SERVICE LETTER SL51 66-11200 & 66-12200

1. Release Date: 11/17/2021
2. Service Letter No.: SL51 66-11200
3. Subject: Water Rudder Rigging Installation
4. Part/Assembly No.: 66-11200 and 66-12200
5. Float Models Affected: 6650 and 6750 on Daher KODIAK 100 AMPHIBIAN OR SEAPLANE
6650 Model Floats, Serial Numbers – 184-185 and previous
6750 Model Floats, Serial Numbers – 106-107 and previous
6. Compliance: Mandatory Recommended Optional
7. Approval: All information provided is in accordance with approved data.
8. Corrective Action: Non-required.
9. Estimated Time Required: 1.5 hours
10. Payments: Credit to Customer Under Warranty Customer Pays

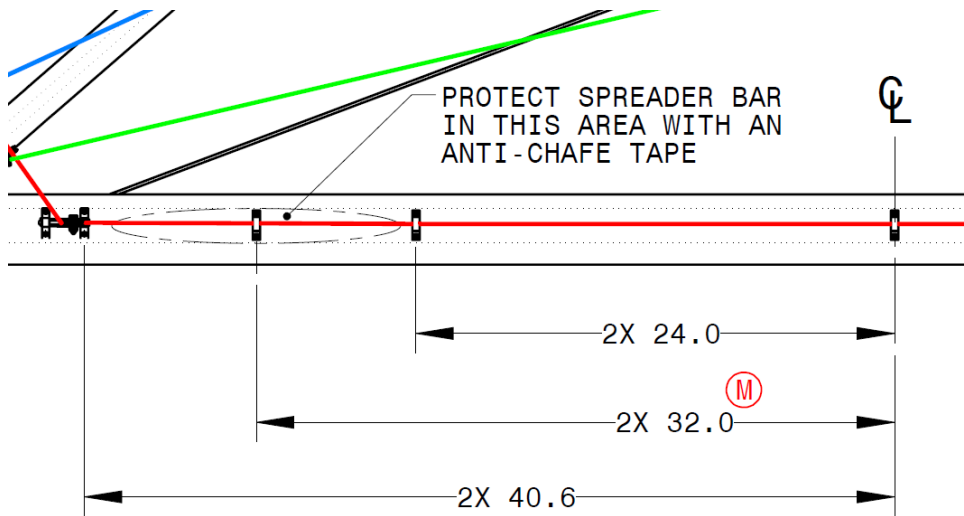
The balance cable is chafing paint from the rear of the rear spreader, likely due to turbulence in that region. This service letter is recommending the addition of a set of cable guides (56-15270) to the spreader to prevent chafing as well as using anti-chafe tape.

The balance cable (66-12220-17) must be uninstalled to add two cable guide assemblies; one LHS and one RHS of the rear spreader as shown above.

CR3223-4-04 Cherrymax Rivets are supplied with 56-15270(2X).

This is a good opportunity to inspect and replace as necessary the liner bushings used in the cable guides. The part number for these is RSI-0507-06; available from Aerocet, Inc.
